Access Compliance Report

Public Rights-of-Way

(Curb Ramps)

Intersection ID: 10025681	Main Street: EAST_BV	Cross Street: N/A	Location: SW
ADA ID: 69379D0ACC3B	Ramp Type: Perp	Initial Pass/Fail: Fail	Overall Compliance: No
			Severity Score: 13.75

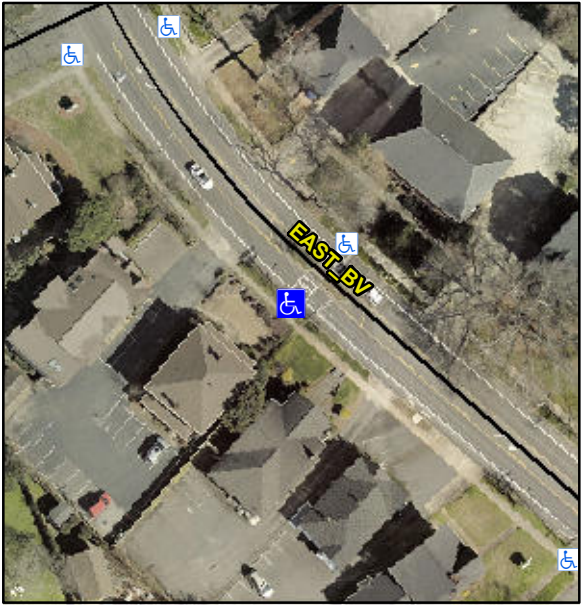
Codes/Mitigation Info/Possible Solution			Field Measurements/Component Compliance		
	Possible Solutions:		Compliance	Description	Data
	Remove & Replace Entire Ramp.		No	Ramp Slope (%)	9.1
			Yes	Ramp Width (in)	2.7
			N/A	Flare Type LT	N/A
			N/A	Flare Slope LT (%)	N/A
			N/A	Flare Traversable LT?	N/A
			N/A	Landing Length (in)	N/A
			N/A	Landing Width (in)	N/A
			N/A	Landing Slope (%)	N/A
			N/A	Landing X Slope (%)	N/A
<p>Surveyor Notes:</p> <p>N/A</p> <p>PROW/ADA:</p> <p>Not Found, R304.2.2</p>			N/A	Flare Type RT	N/A
			N/A	Flare Slope RT (%)	N/A
			N/A	Flare Traversable RT?	N/A
			N/A	DWS Provided?	N/A
			N/A	DWS Contrast?	N/A
			N/A	DWS Length (in)	N/A
			N/A	DWS Full Width?	N/A
			N/A	DWS Offset (in)	N/A
			N/A	Gutter Ponding?	N/A
			N/A	Gutter Lip Ht (in)	N/A
			Yes	Painted X Walk1?	N/A
			To NE	X Walk 2 Direction	N/A
			N/A	X Walk 2 Width (in)	N/A

1.9	X Walk 2 Slope (%)	N/A
			4.0	X Walk 2 X Slope (%)	N/A
			N/A	Ramp inside XWalk2?	N/A
			N/A	Clear Space?	N/A
			N/A	Clear Space to XWalk (in)	N/A
			N/A	Storm Grate/Utility Hazard?	N/A
			N/A	Storm Grate/Utility Type	N/A
Total Cost:		\$ 1850.00			
			N/A		N/A
			Yes	Surface Condition? (G/P)	Good
